Access Compliance Report

Public Rights-of-Way

(Curb Ramps)

Intersection ID: 19817	Main Street: MONROE_RD	Cross Street: TIMBER_SPRINGS_DR	Location: NW
ADA ID: 9A3E22F95A8A	Ramp Type: Perp	Initial Pass/Fail: Fail	Overall Compliance: No
Severity Score: 21.25			
Codes/Mitigation Info/Possible Solution		Field Measurements/Component Compliance

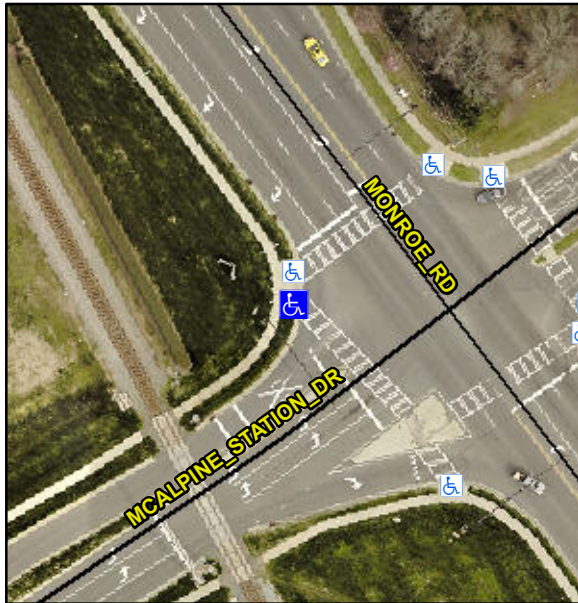
R304.5.1, R304.2.2

Compliance	Description	Data	Compliance	Description	Data
N/A	Ramp Length (in)	96.0	No	Ramp Slope (%)	9.5
No	Ramp Width (in)	47.5	Yes	Ramp XSlope (%)	2.0
N/A	Flare Type LT	N/A	N/A	Flare Type RT	N/A
N/A	Flare Slope LT (%)	N/A	N/A	Flare Slope RT (%)	N/A
N/A	Flare Traversable LT?	N/A	N/A	Flare Traversable RT?	N/A
N/A	Landing Length (in)	N/A	N/A	DWS Provided?	N/A
N/A	Landing Width (in)	N/A	N/A	DWS Contrast?	N/A
N/A	Landing Slope (%)	N/A	N/A	DWS Length (in)	N/A
N/A	Landing X Slope (%)	N/A	N/A	DWS Full Width?	N/A
N/A	Landing Curb? (Y/N)	N/A	N/A	DWS Offset (in)	N/A
N/A	Shared Landing?	N/A			
N/A	Gutter Ponding?	N/A	N/A	Gutter Slope (%)	N/A
N/A	Gutter Lip Ht (in)	N/A	N/A	Gutter X Slope (%)	N/A
N/A	Painted X Walk1?	Yes	N/A	Painted X Walk2?	N/A
	X Walk 1 Direction	To SE		X Walk 2 Direction	N/A
N/A	X Walk 1 Width (in)	115.0	N/A	X Walk 2 Width (in)	N/A
	X Walk 1 Slope (%)	1.6		X Walk 2 Slope (%)	N/A
	X Walk 1 X Slope (%)	0.3		X Walk 2 X Slope (%)	N/A

Remove & Replace Entire Ramp.
